MILITARY SPECIFICATION

MODULES, STANDARD ELECTRONIC

TRANSFORMER, SIGNAL, ANALOG, KEY CODE CGR

This amendment forms a part of Military Specification MIL-M-28787/240A(EC), dated 31 January 1983, and is approved for use by the Naval Electronic Systems Command, Department of the Navy, and is available for use by all Departments and Agencies of the Department of Defense.

FIGURE 11. Maximum power check (distortion test) test circuit for table X.

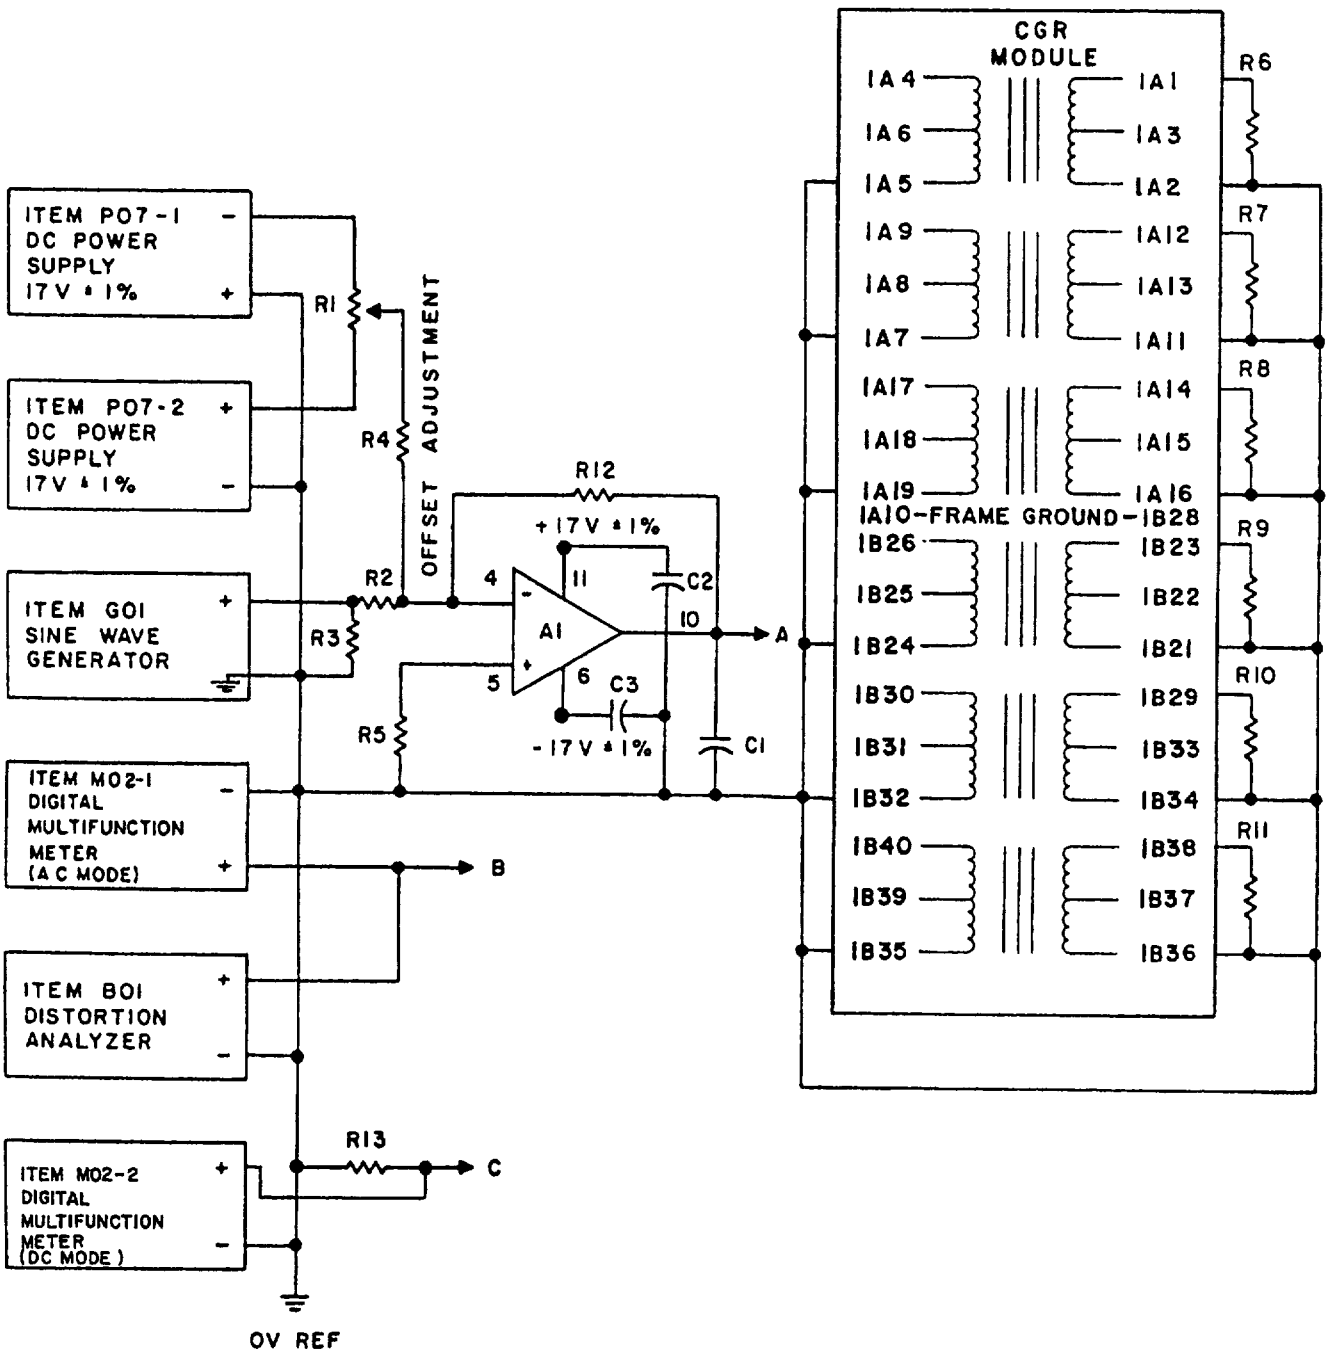
FIGURE 11: Delete and substitute new figure 11 as printed on pages 2 and 3 of this amendment.
